TITLE	MOTORIZED ROLLING SHUTTER			NIHVA TECHNOLOGIES PVT. LTD. PUNE Tel : 020 66304033 Email:- info@nihva.com Website:- www.nihva.com
	NAME	SIGN	DATE	
DRAWN	P.A		19.11.2019	CLIENT - WANI
CHECK	G.J		19.11.2019	PROJECT - BRIDGESTONE
APPRD.				SITE LOCATION - CHAKAN
If any queries contact : design@nihva.com				DWG. NO. : NIHVA/19-20/0154 REV- R00
ALL DIMENSION ARE IN mm				SCALE: NTS WT: SHEET:

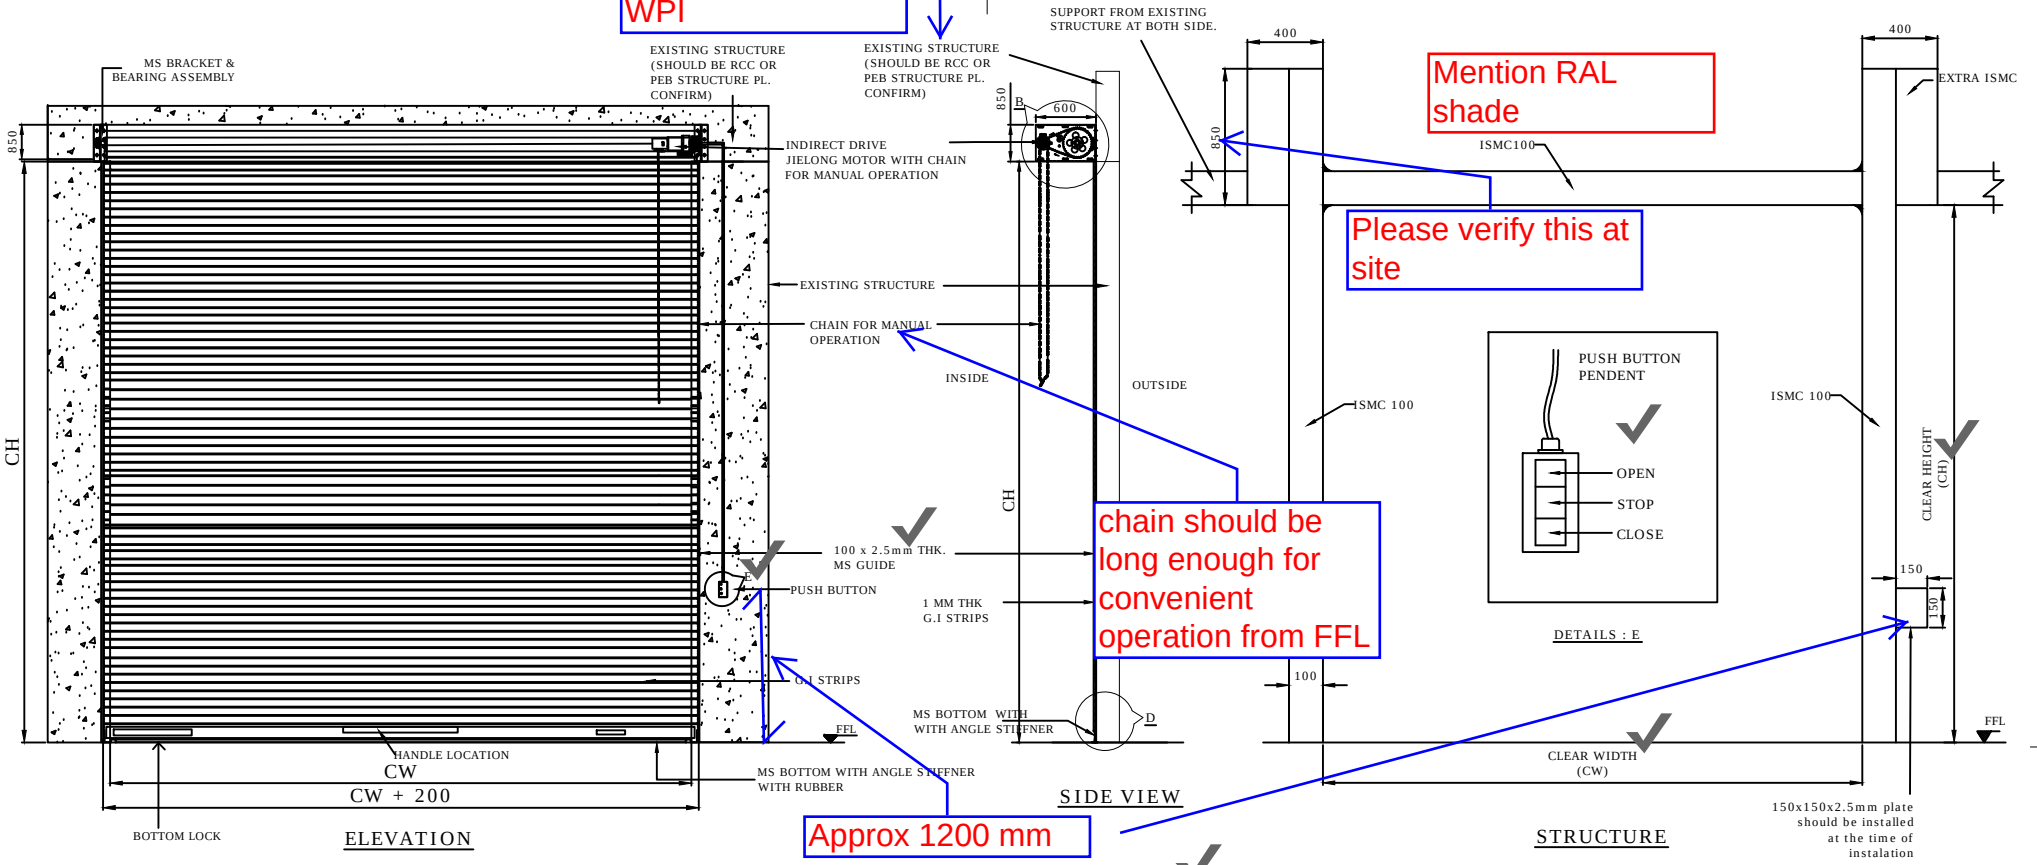
Steel sections by WPI

DETAILS : D

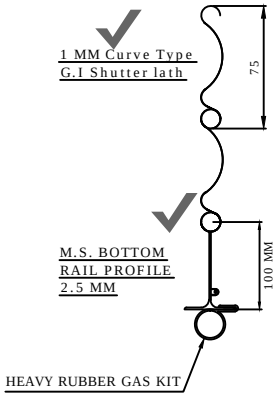
Mention RAL shade

Please verify this at site

chain should be long enough for convenient operation from FFL

Approx 1200 mm
